24 May 2016

Our Ref: P13-206 (MW)

RE: RESPONSE TO ASSESSMENT REPORT FOR DEVELOPMENT APPLICATION (DA) 327/2015 FOR DEVELOPMENT AT 101-111 WILLOUGHBY ROAD, CROWS NEST

LEVEL 1 PLAN 1:400 @ A3 1:200 @ A1 23.05.16 3844_DA016

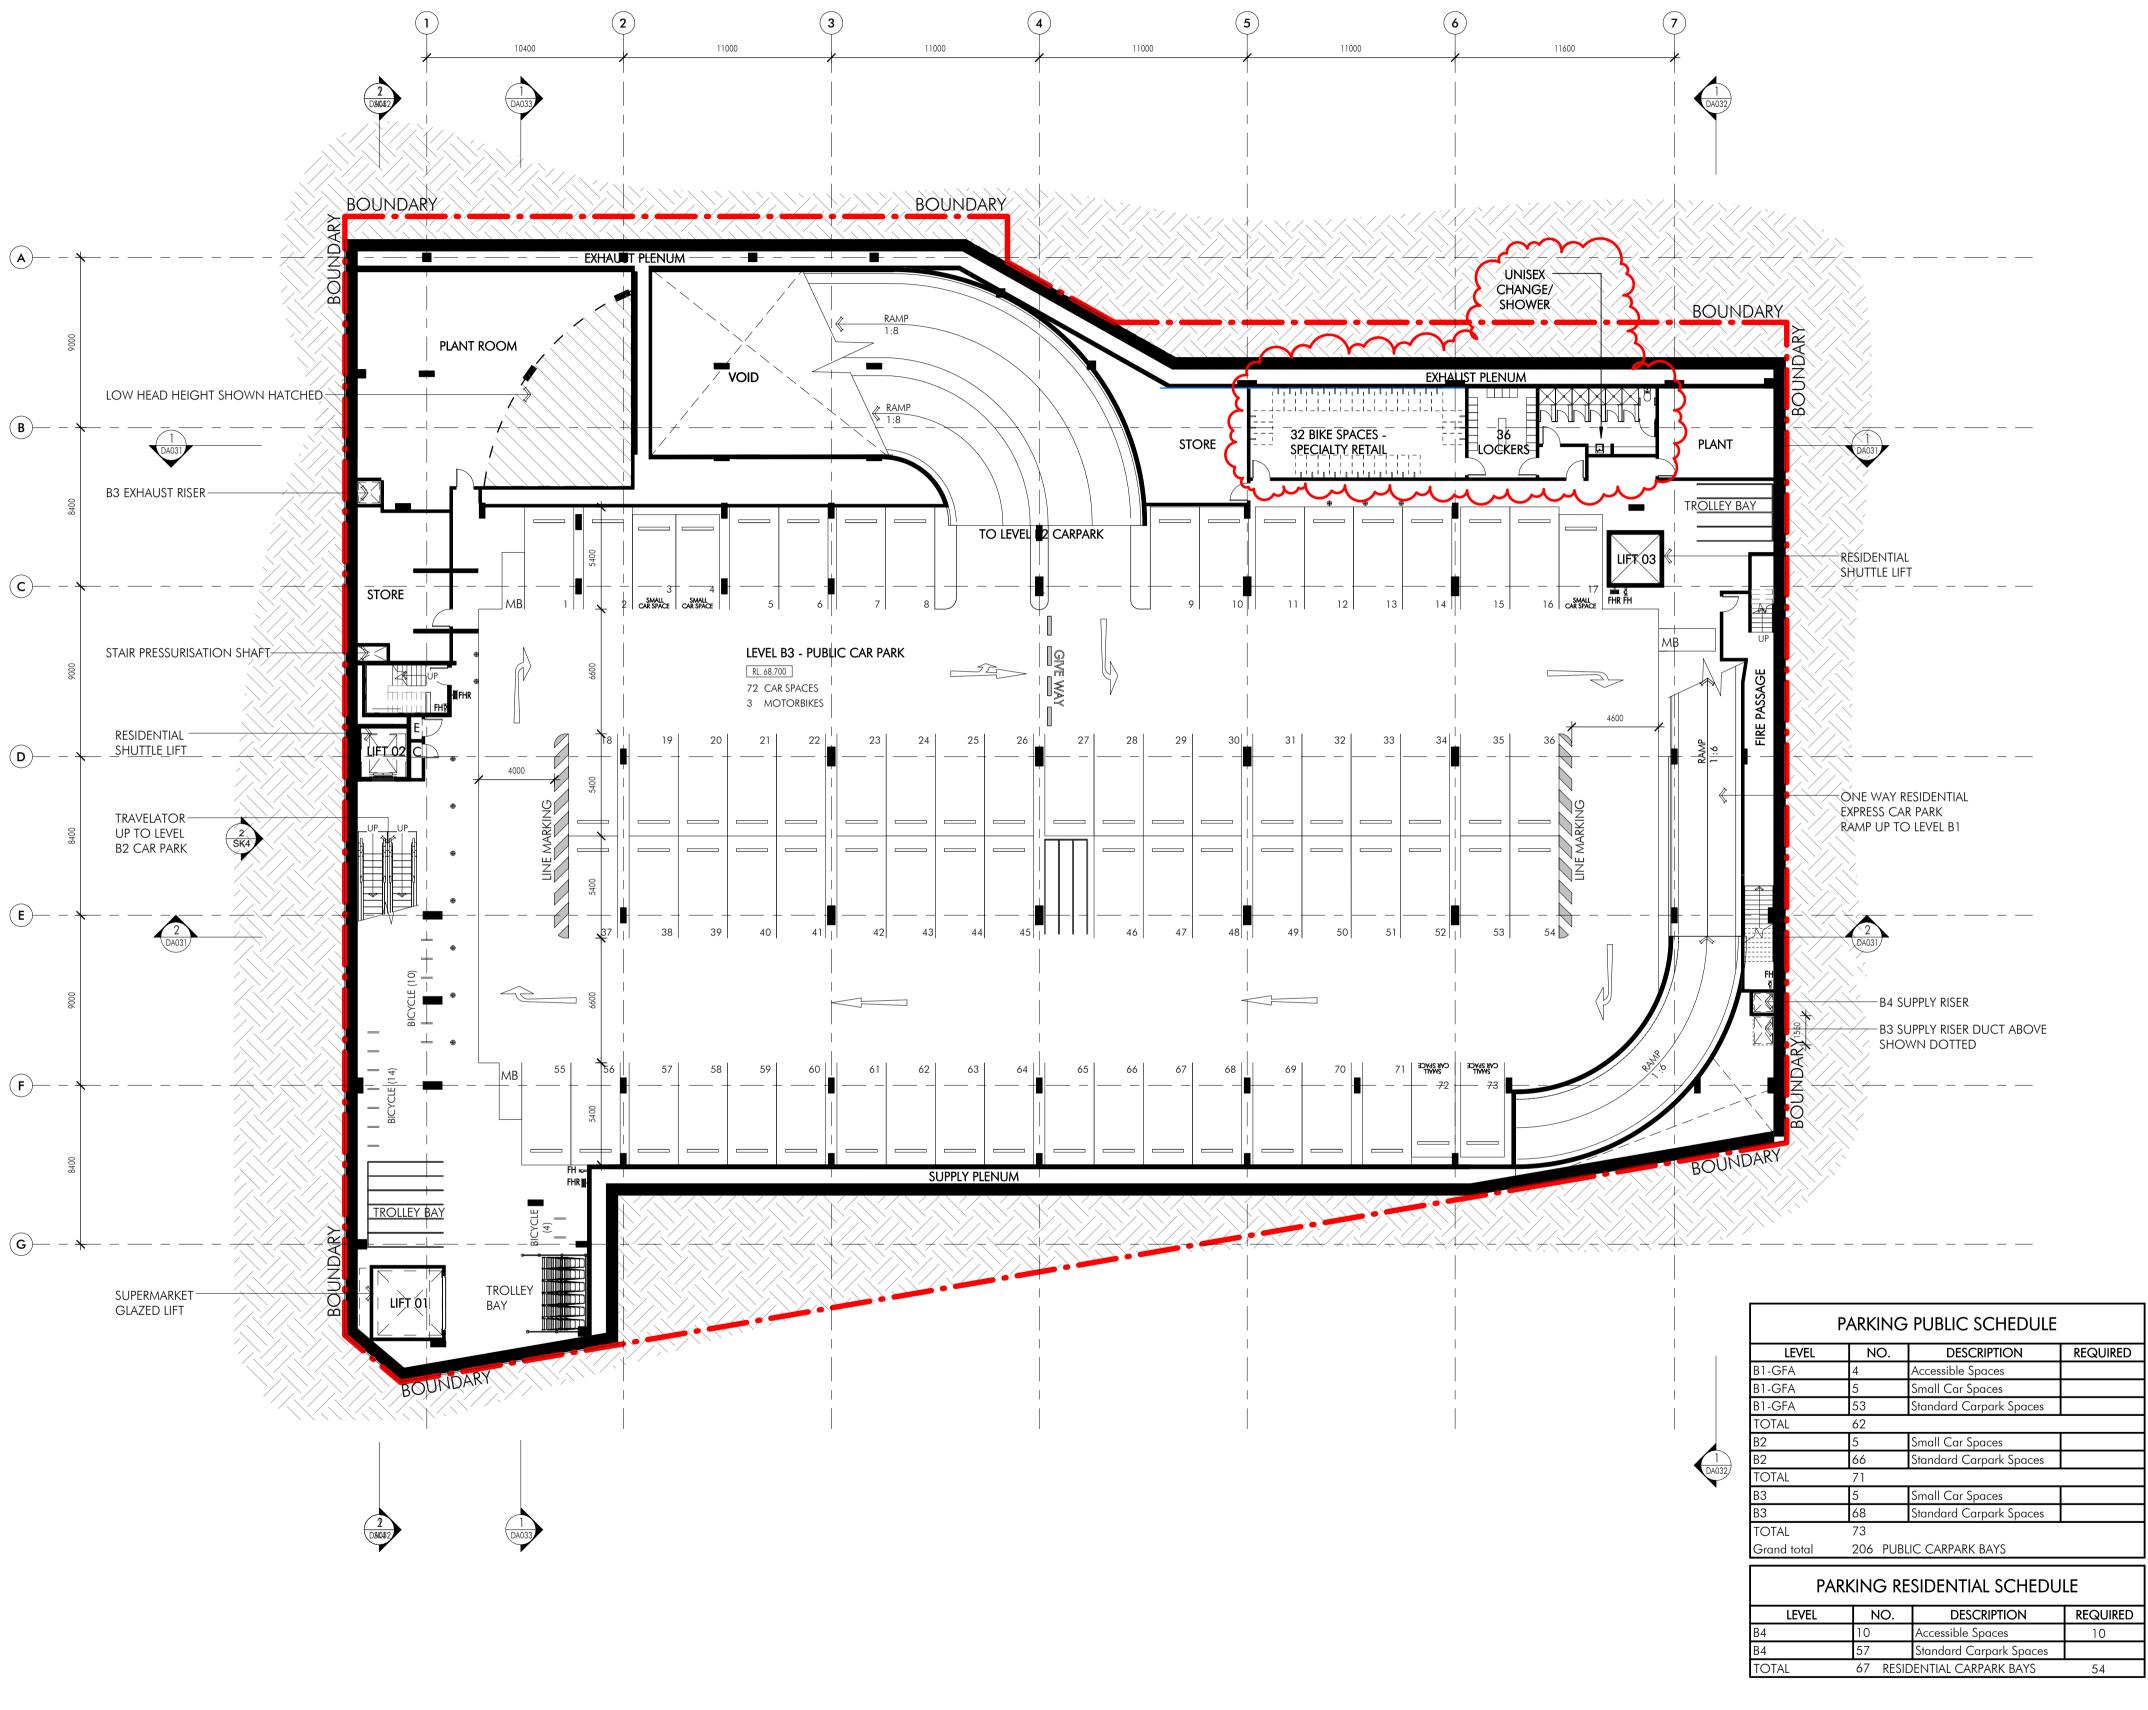
- "Apartments 105, 106, 205, 206, 305 and 306 could be redesigned to provide all bedrooms opening towards Willoughby Road and provide private open space compliant with the minimum depth requirement (ie 2m for 2 bedroom and 2.4m for 3+ bedroom apartments). One solution would be to consolidate each pair of apartments into a single 3 bedroom apartment with a deep balcony allowing bedrooms and living room to open directly onto the balcony or Willoughby Street."

- "Apartment 407 is identified as being a studio apartment but is clearly a one bedroom apartment and has an inadequate area of only 45m2. The size of this apartment is inadequate and the terrace is disproportionately large. In order to address this concern and improve the dwelling mix Apartment 407 could be consolidated with Apartment 403 to create a substantial 3 bedroom apartment."

- Apartments 107, 207 and 307 are considered inappropriately small, particularly given that 4.5m2 of the area is compromised space, being a hallway. These apartments also have compromised balconies, which whilst compliant with the size are of inadequate width These apartments could be converted into a 1 bedroom apartments with a balcony having an area of at least 8m2, with a minimum 2m depth.

- Apartments 117-120 could be reconfigured so that compliant internal and external spaces are provided in accordance with the Apartment Design Guide having regard to minimum apartment size, balcony size and balcony depth (ie 2m for 1 and 2 bedroom apartments).

- Apartments 102, 202, 213, 214, 217, 218, 302, 313, 314, 316 and 317 are provided with balconies which are narrower than the minimum 2m requirement and could be redesigned to provide balconies with minimum areas of 10m2, with minimum dimensions of 2m and have internal areas of 70m2 (where 1 bathroom is proposed) or 75m2 where two bathrooms are proposed".

- The main concern related to the amenity (outlook and ventilation) of the bedrooms facing the common lobby of these units (units 105, 106, 205, 206, 305 and 306). Whilst it was considered that the units in their original form were suitable and would have received satisfactory amenity, the plans have been amended (Annexure 1) to provide a revised layout to ameliorate the concerns raised. The three (3) bedroom option suggested by KGPS was considered, however, the layout of the unit was not efficient or suitable given the orientation and depth of the unit. Nettletontribe have amended the plans with an alternate arrangement which involves converting them

into studio apartments. The design of the studio apartments satisfies the requirements of the ADG as detailed in the revised plans prepared by Nettletontribe Architects at **Annexure 1**. These changes, along with the other changes discussed below has resulted in an additional three (3) new units.

- Apartment 407 has been amended to remove an internal wall so that it is more in keeping with a 'studio' unit (refer to **Annexure 1**). The option suggested by KGPS was considered, however, this did not result in a unit that was efficient. As a result of the overall amendments, the unit mix has altered which has increased the number of studio units and three bed units. Whilst the development is now more consistent with the unit mix as required under Council's DCP, the unit mix is reflective of the current market demand for the area. As such, the mix is considered suitable and additional 3 bed units are not required.

- The concern related to the size of units 107, 207, and 307. To address these issues the plans have been amended and the abovementioned units have now been consolidated with units 108, 208 and 308 and converted into three (3) bedroom units. The new units satisfy the requirements of the ADG as demonstrated in the revised Plans and ADG compliance table prepared by Nettletontribe Architects at Annexures 1 and 2.

- The concerns related to the size and dimensions of the balconies to units 117-120. Unit 117 is compliant with the requirements of the ADG, and the suggestion that it is non-compliant is incorrect particularly given it has a large terrace (21m²) that is situated on the podium. Units 118 to 120 have been amended to include balconies that have an area of 8m² and a minimum depth of 2m, which satisfies the requirements of the ADG. Refer to Annexures 1 and 2 for detail.

- The concern related to the balcony areas for units 102, 202, 213, 214, 217, 218, 302, 313, 314, 316 and 317. It is considered that the areas of the balconies for these units were compliant with the requirements of the ADG in terms of balcony areas and depths. In this respect, and as discussed in our response to Council in our letter dated 12 February 2016 all of these balconies satisfied the minimum area, and minimum depth of 2m, noting that the ADG allows the following:
